2018 NC State Residential Code Amendments

(adopted December 2017 through September 2021)

2018 NC Residential Code (based on the 2015 International Residential Code) effective 1/1/2019

These amendments revise, delete or add to the adopted NC Residential Code.

FIGURE R602.10.1
METHOD PF – PORTAL FRAME CONSTRUCTION

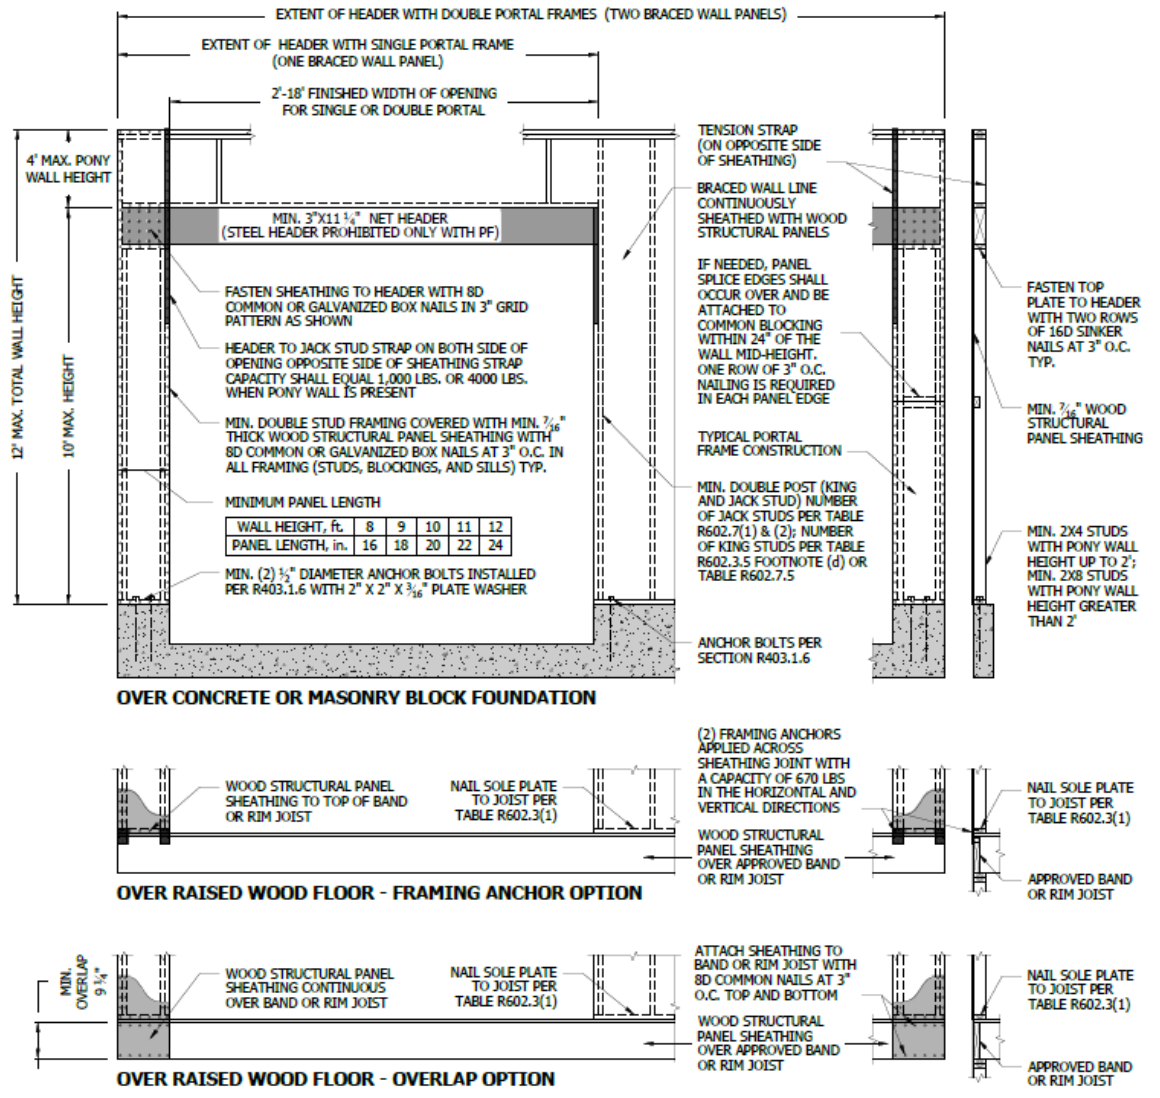
ERRATA – corrected jack stud reference in Figure R602.10.1 – Method PF-Portal Frame Construction on page 134.

FIGURE R4603.6(d)
CORNER PILE CONNECTION

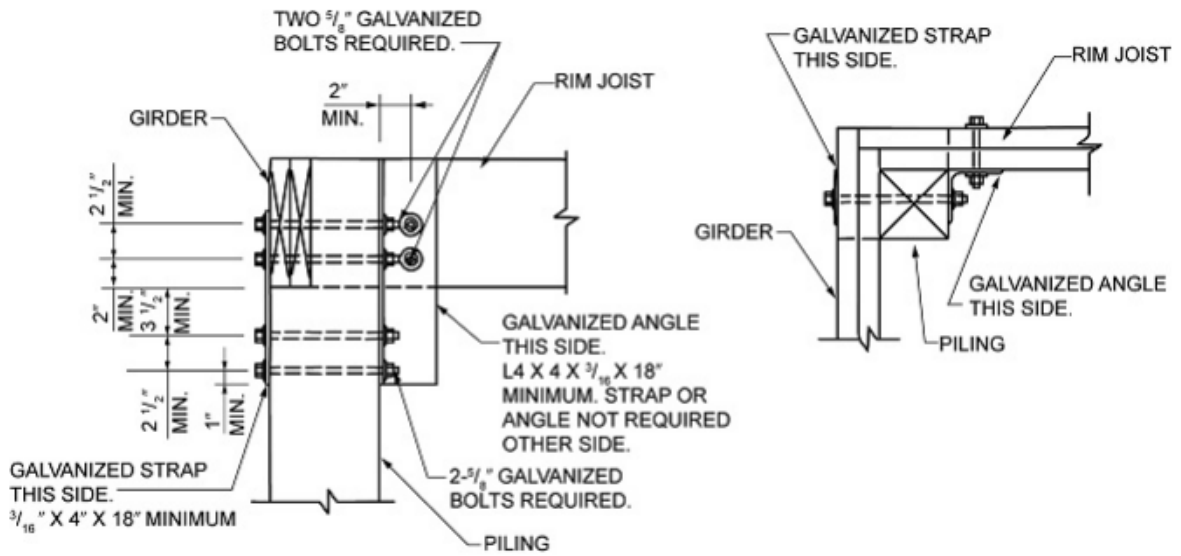
R4603.6.1 Tying at corners. At corners, girders shall be connected to the pile with a minimum 3/16 × 4 × 18-inch (5 × 102 × 467 mm) hot dip galvanized strap bolted with two 5/8 inch (15.9 mm) galvanized through bolts on the exterior and a minimum L4 x 3/16 x 1'-6" (102 × 5 × 467 mm) galvanized steel angle bolted with two 5/8 inch (15.9 mm) galvanized through bolts on the interior in accordance with Figure R4603.6(d).

FIGURE R4603.6(e)
CORNER PILE CONNECTION

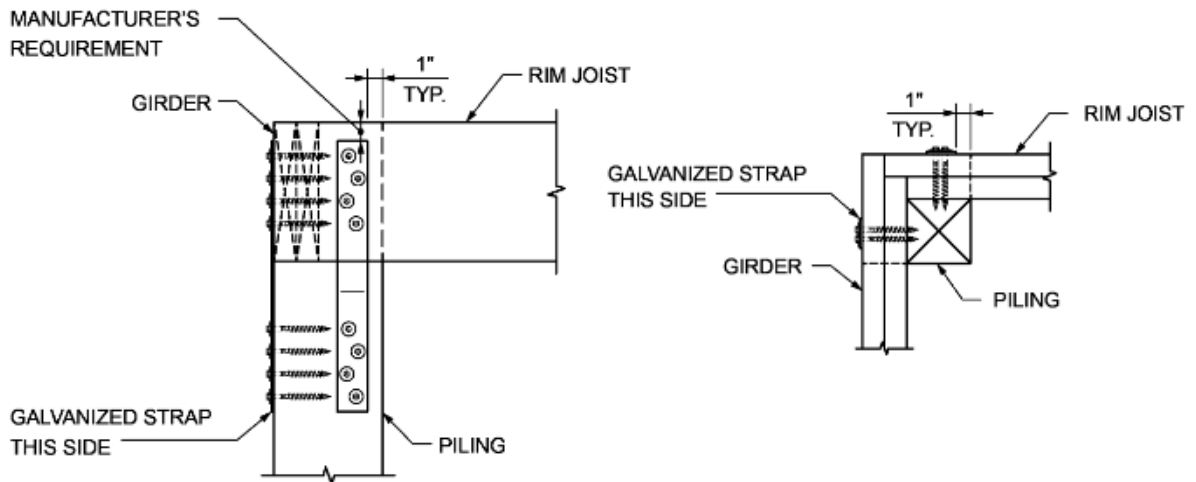
R4603.6.1 Tying at corners. At corners, girders shall be connected to the pile with a minimum 3/16 × 4 × 18-inch (5 × 102 × 467 mm) hot dip galvanized strap bolted with two 5/8 inch (15.9 mm) galvanized through bolts on the exterior and a minimum L4 x 4 x 3/16 x 1'-6" (102 × 5 × 467 mm) galvanized steel angle bolted with two 5/8 inch (15.9 mm) galvanized through bolts on the interior in accordance with Figure R4603.6(d), or with a minimum of (2) 3/16" x 4" x 18" (5x102x467 mm) hot dip galvanized straps installed on the outside of the girders with fasteners per Table R4603.6.1 and in accordance with Figure R4603.6 (e).

<u>Amount Piling is Notched</u>	<u>Associated Figure</u>	<u>Hardware</u>	<u>Fasteners</u>
<u>> 50%¹</u>	<u>R4603.6(d)</u>	<u>one 3/16" x 4" x 18"</u>	<u>six 5/8" bolts²</u>
		<u>one L4 x 4 x 3/16 x 18"</u>	
	<u>R4603.6 (e)</u>	<u>two 3/16" x 4" x 18"</u>	<u>eight 0.27"x4" each strap³</u>

**FIGURE R4603.6(b)
TOP MOUNTED GIRDER**

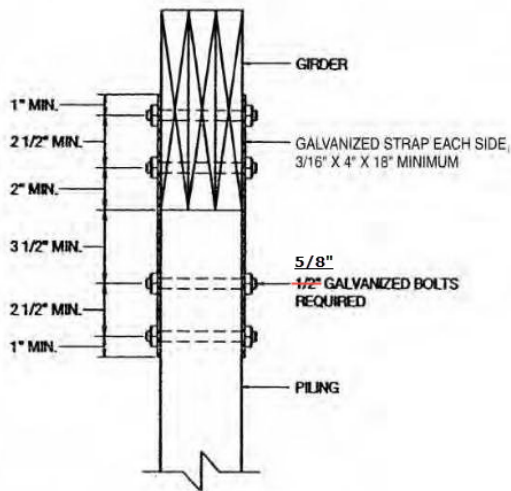
Revise Figures as follows:

**FIGURE AM109.1(2)
KNEE BRACING**

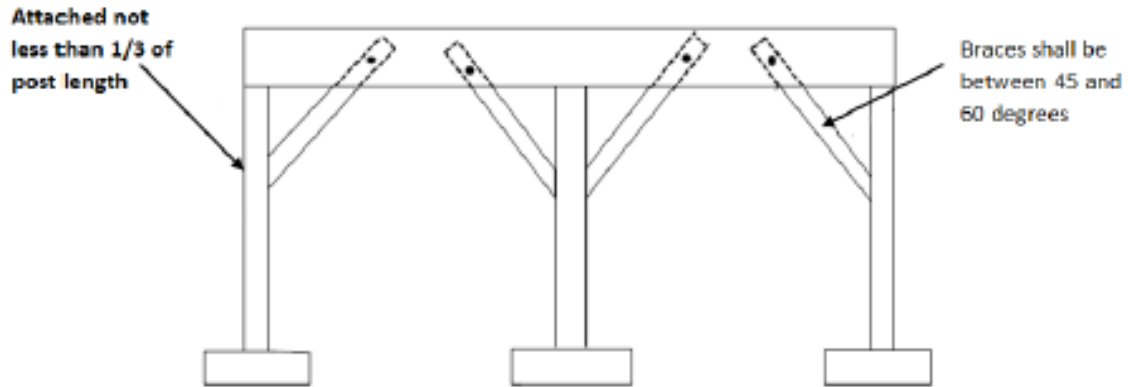
4x4 wood knee braces are permitted to be provided on each column in both directions for freestanding decks or parallel to the structure at the exterior column line for attached decks per Figure AM109.1(2). The knee braces shall attach to each post at a point not less than 1/3 of the post length from the top of the post, and the braces shall be angled between 45 degrees (0.79 rad) and 60 degrees (1.05 rad) from the horizontal. Knee braces shall be ~~bolted~~ fastened to the post and the girder/double band in accordance with one 5/8 inch (16 mm) hot dip galvanized bolt with nut and washer at both ends of the brace of the methods shown in Table AM109.1, as shown in Figure AM109.1(2).

**FIGURE AM109.1(4)
CROSS BRACING**

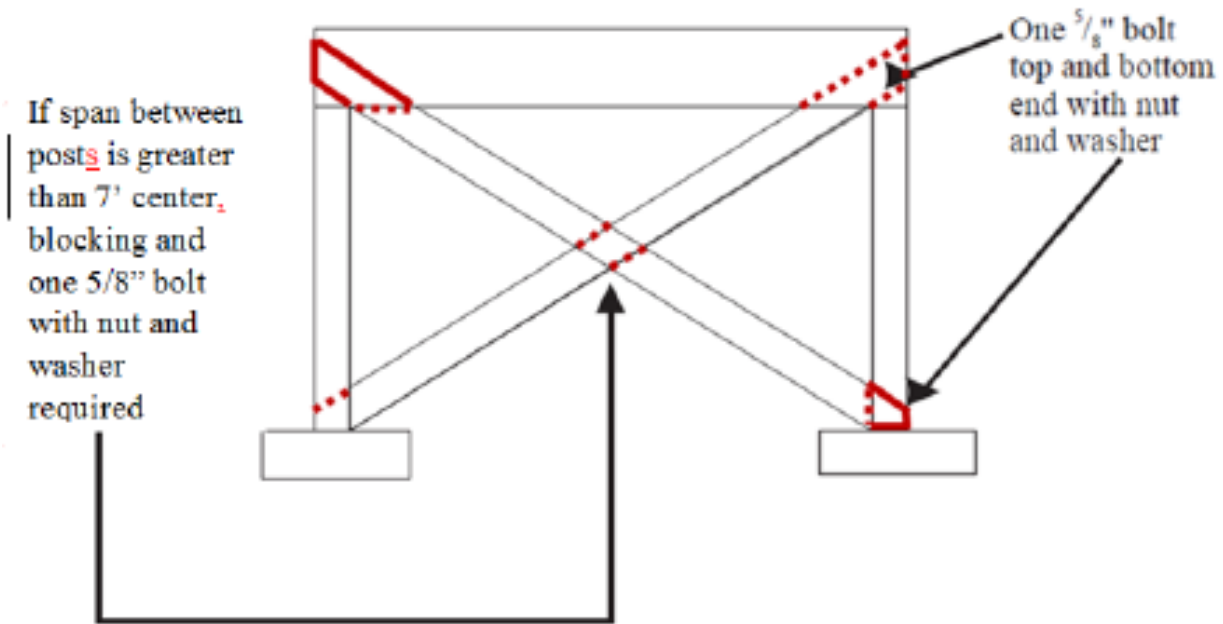
2x6 diagonal vertical cross bracing is permitted to be provided in two perpendicular directions for free standing decks or parallel to the structure at the exterior column line for attached decks. The 2x6 bracing shall be attached to the posts with one 5/8 inch (16 mm) hot dip galvanized bolt with nut and washer at each end of each bracing member per Figure AM109.1(4).

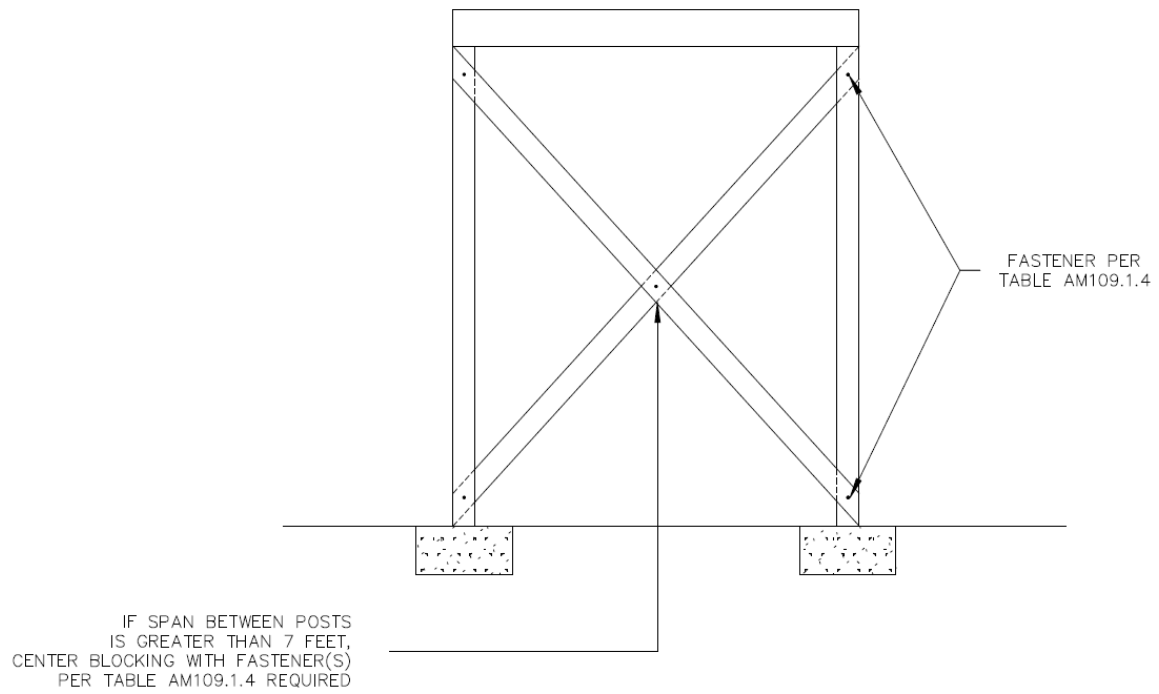
ERRATA – Figure AM109.1(4) corrected bracing location and lapping (200708).
